FINAL SUPPLEMENTAL ENVIRONMENTAL IMPACT STATEMENT

Betze Pit Expansion Project

Elko District Office - Nevada

March 2009
NT-FES-09-03

Figure 2-15
Reclamation Chronology:
Clydesdale and Bazza
Waste Rock Facilities

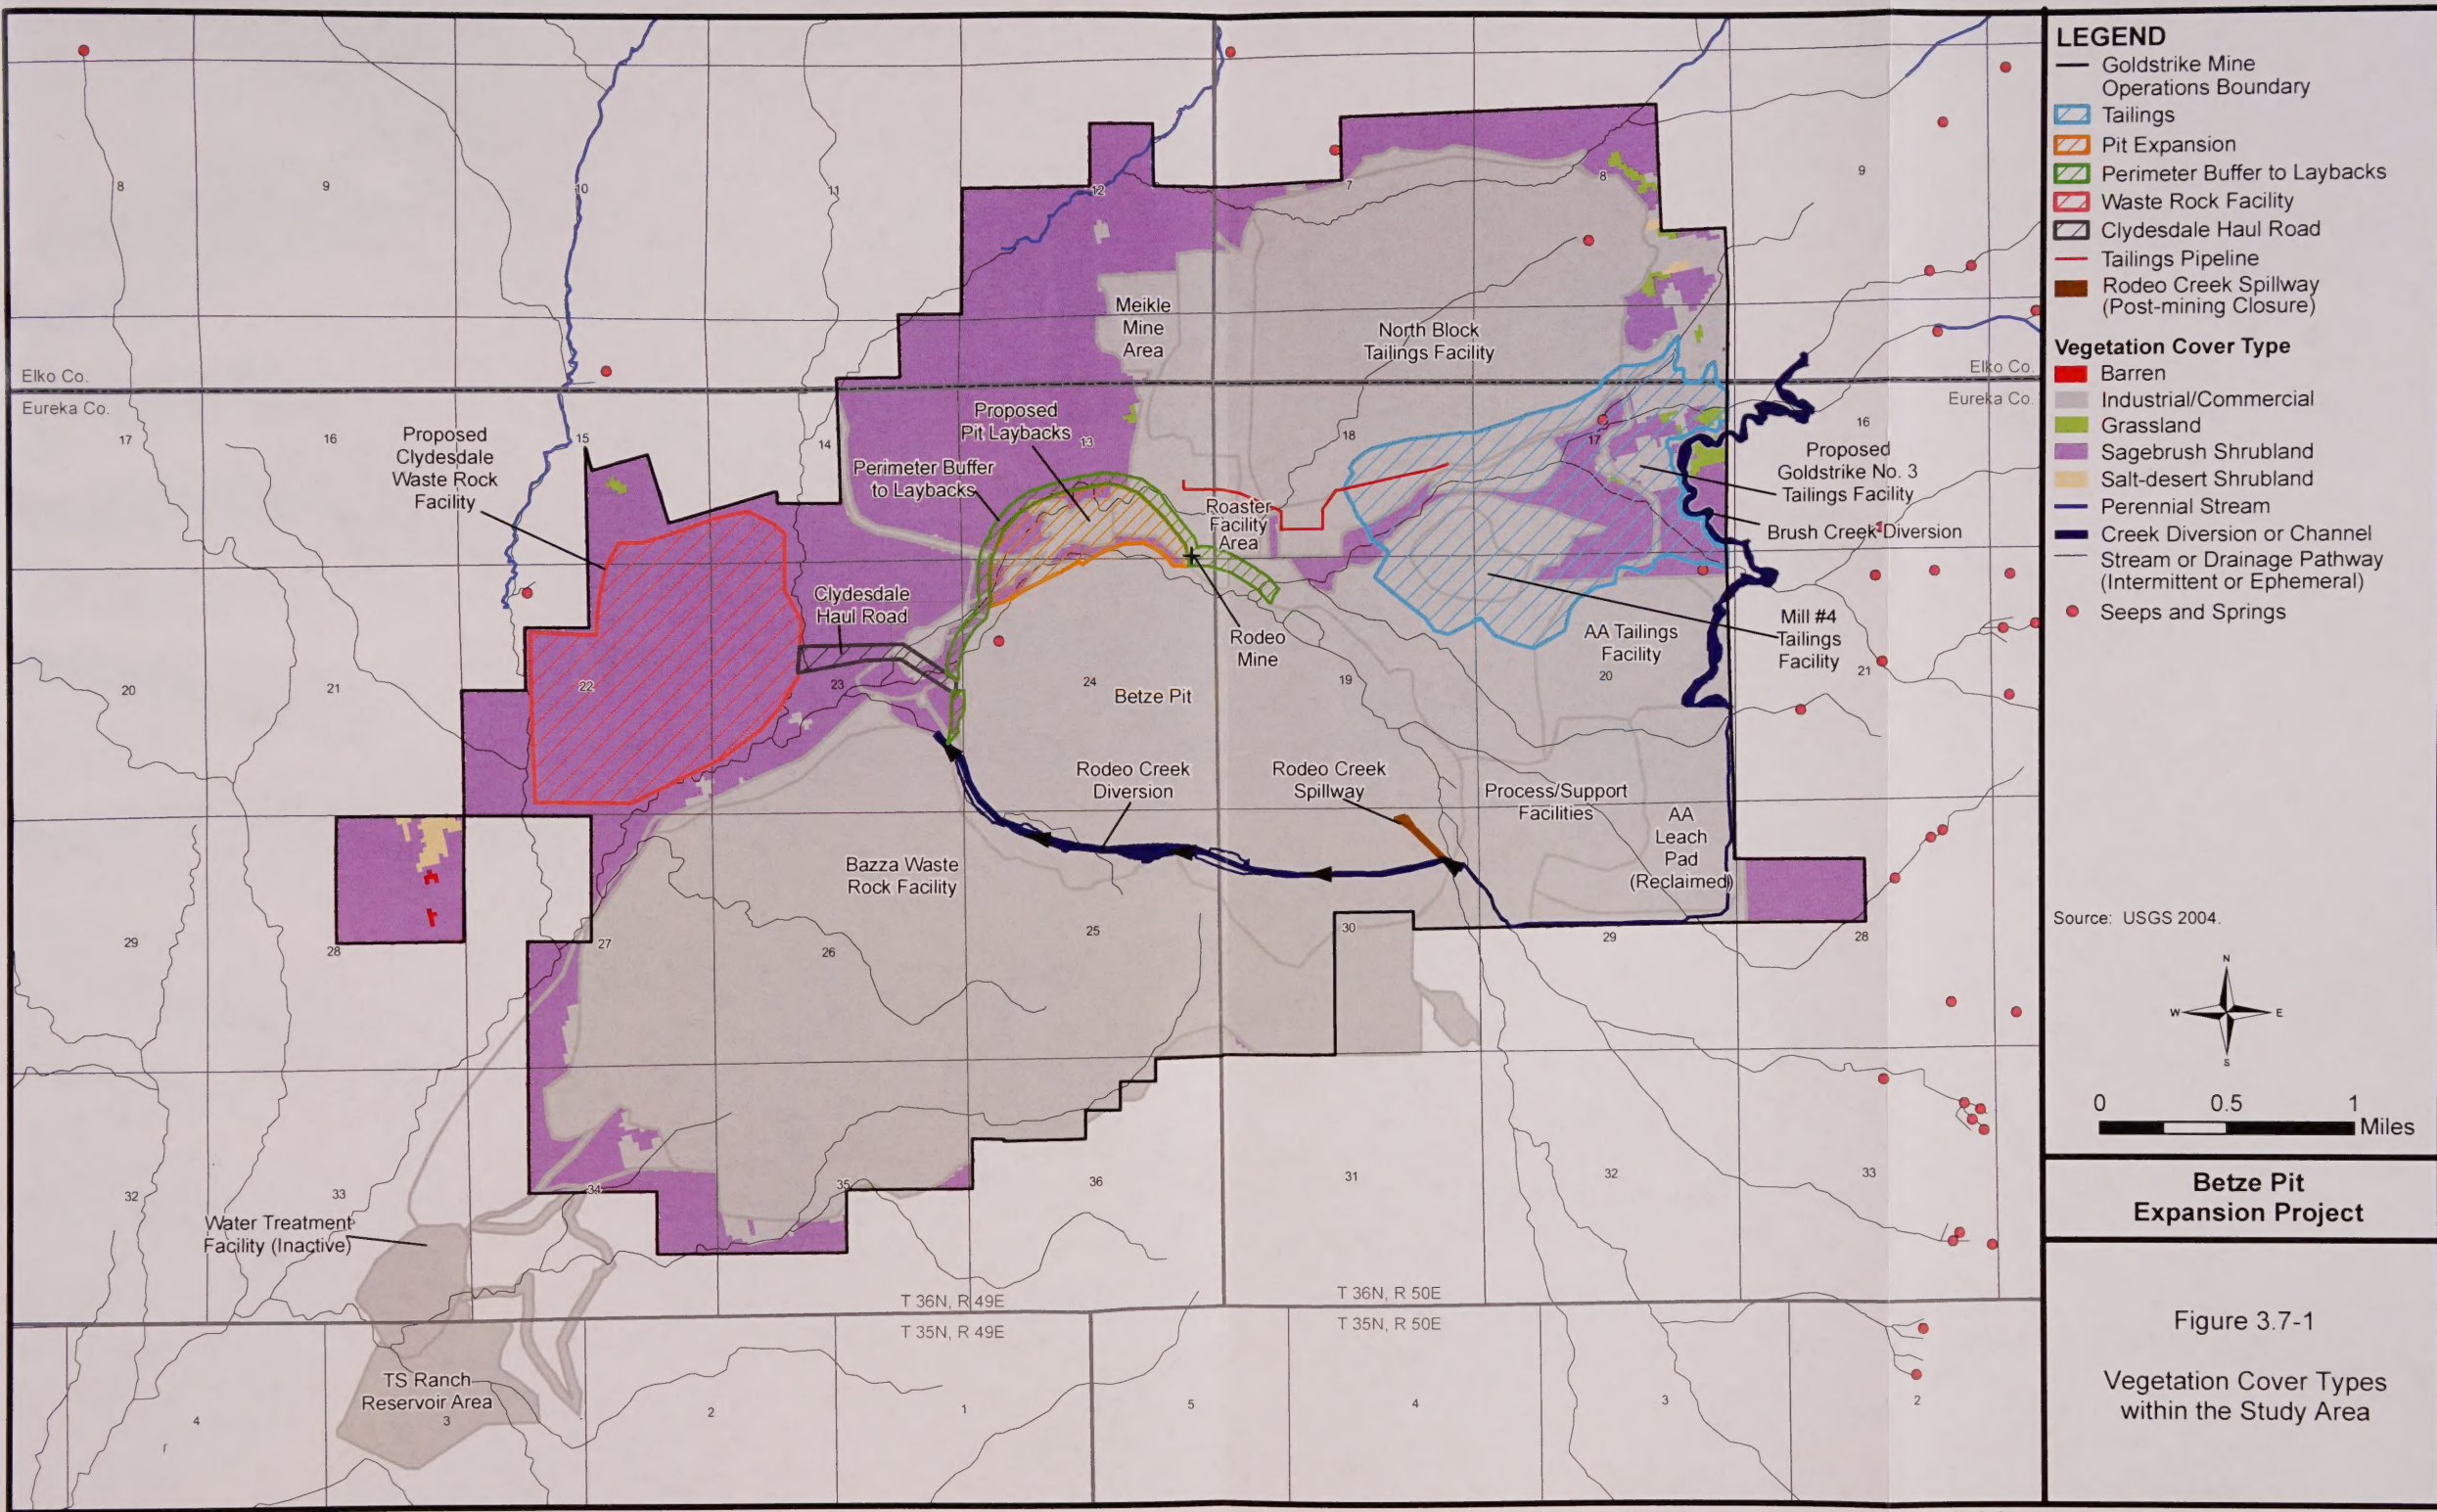
N2-44 Figure 2-15, showing the Reclamation Chronology for the existing Bazza waste rock dump and for the proposed Clydesdale WRD, clearly shows three sections of the Bazza WRD to not be reclaimed until 2033-2035 (they are the purple areas in the middle of the WRD). Under the alternative in Section 2.4 of not building the new Clydesdale WRD, the SEIS indicates that a reason to build the new WRD is that reclamation of the Bazza WRD "would not be completed until 2018, a delay of 7 years compared with the Proposed Action" (SEIS, page 2-56). There is clearly an error here, either in figure 2-15, or in the reasoning for building the Clydesdale WRD.

- N2-44 Figure 2-15 indicates that the advantages of early reclamation of the Bazza WRD are illusory or wrongly expected.
- N2-45 Another reason the SEIS uses for constructing a new WRD is that the properties that make the Carlin material useful for reclamation will be lost due to storage (SEIS, page 2-56). But, the SEIS should explain how the same is not true for storing Carlin formation material for the new WRD.

F1-7 Figure 2-15 was revised. The evaporation/evapotranspiration (ET) cells are now depicted. The two cells are estimated to total approximately 134 acres. Text in Section 2.3.7.3 (page 2-54) has been modified to include more evaporation/ET cell details.

- N2-44 Under the Proposed Action, the entire 2,524-acre Bazza Waste Rock Facility would be reclaimed by 2012 except for approximately 149 acres that comprise the existing ore stockpiles (purple color on Figure 2-15, page 2-46) and the stockpile access road (Figure 2-15, page 2-46), estimated at 44 acres (3.65 miles by 120-foot width) and the landfill (17 acres). The ore stockpiles, landfill, and access road would be reclaimed in 2033 to 2035 after the last of the ore is processed through the mill. Under the No Action and Bazza Waste Rock Facility Alternatives, the Bazza Waste Rock Facility would not be reclaimed until 2018, and the Bazza waste Rock Facility 7 years after the Proposed Action. The

- N2-44 (Cont) existing ore stockpiles, access road, and landfill would not be reclaimed until 2028-2035 depending on alternative.
- Figure 2-15 was modified to label the ore stockpiles that are colored purple. The first paragraph on page 2-50 was modified to clarify that the existing ore stockpiles, landfill, and access road on the Bazza Waste Rock Facility would not be reclaimed until 2033-2035, the same timeframe as the Proposed Action.

Figure 1. Simulated base flow at Rock Creek from Newmont's EIS model.

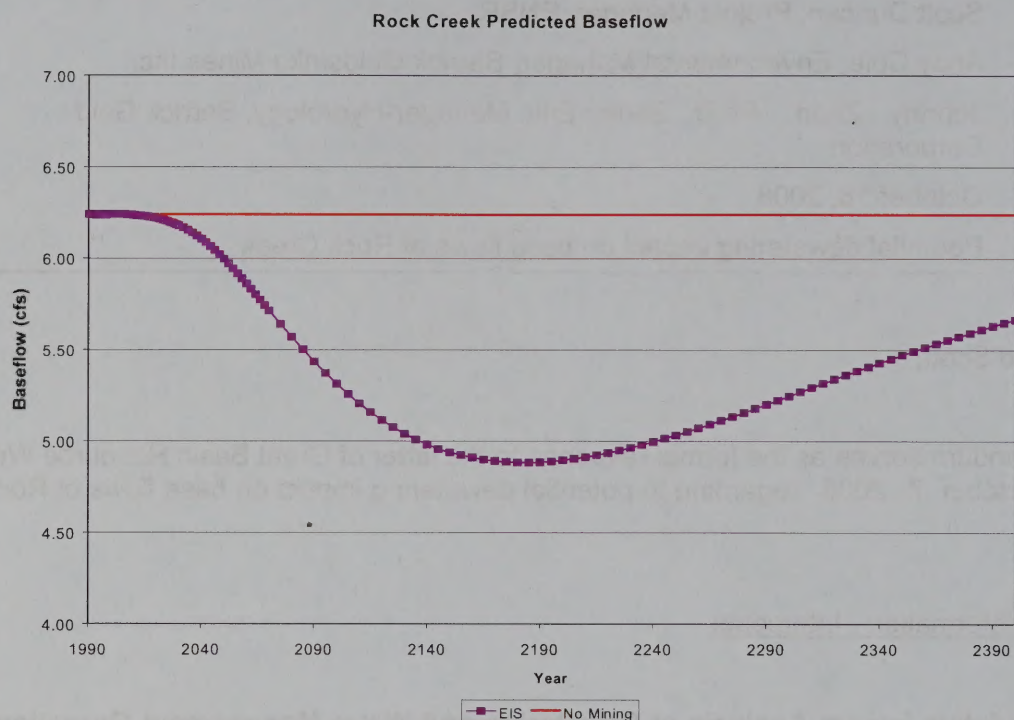
Figure 1 is the output from Newmont's EIS model, which shows the flows with and without mining. The difference between these two conditions, so called base flow reduction (1.5 cfs), can be derived from this figure.

Figure 3. . Measured water level at the triggering point (NA-51S).

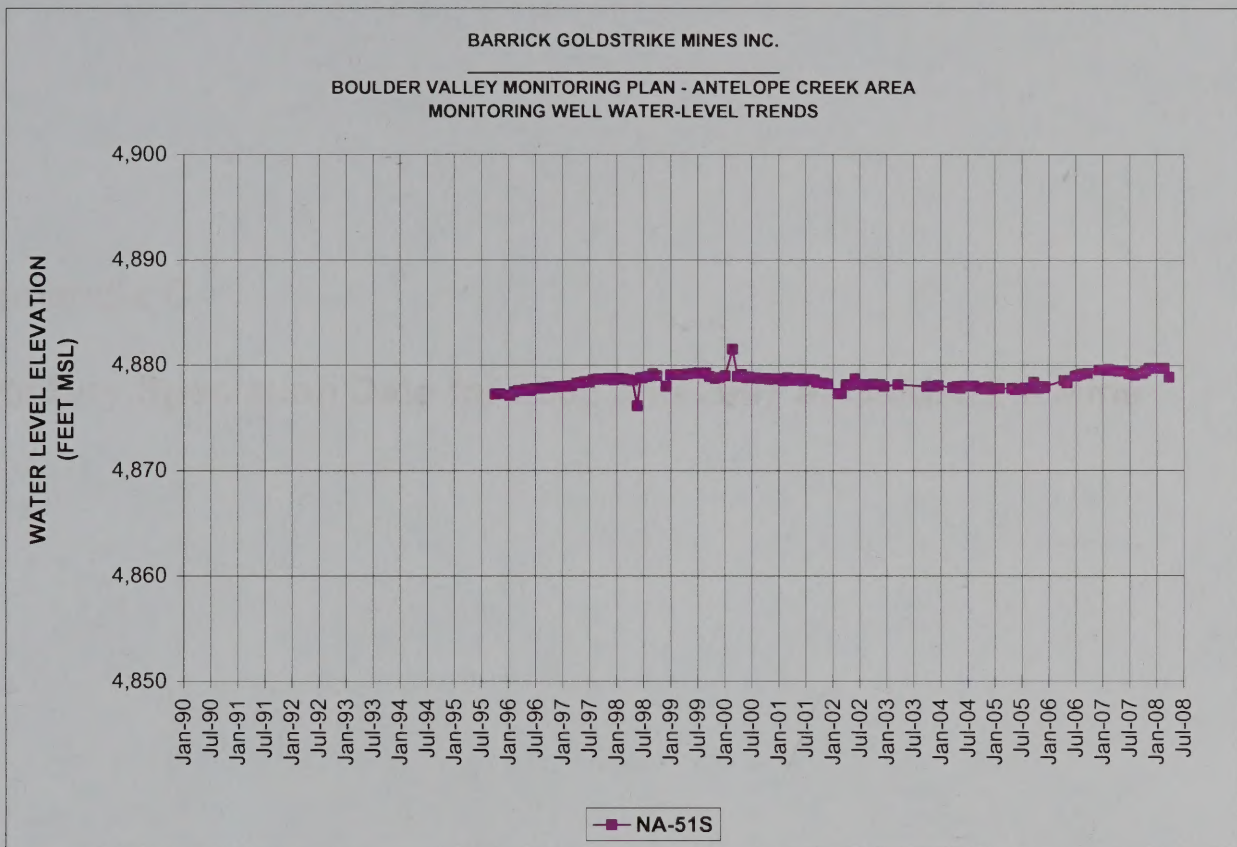
NA-51S is an existing piezometer located to the west of the Betze pit. It lies between the measured drawdown from the dewatering operation and Rock Creek. It was specified that if NA-51S shows more than 10 feet of drawdown on the annual basis, it will trigger Barrick take additional monitoring/mitigation action. As indicated on Figure 3, water levels in NA-51S have shown no impact from dewatering.
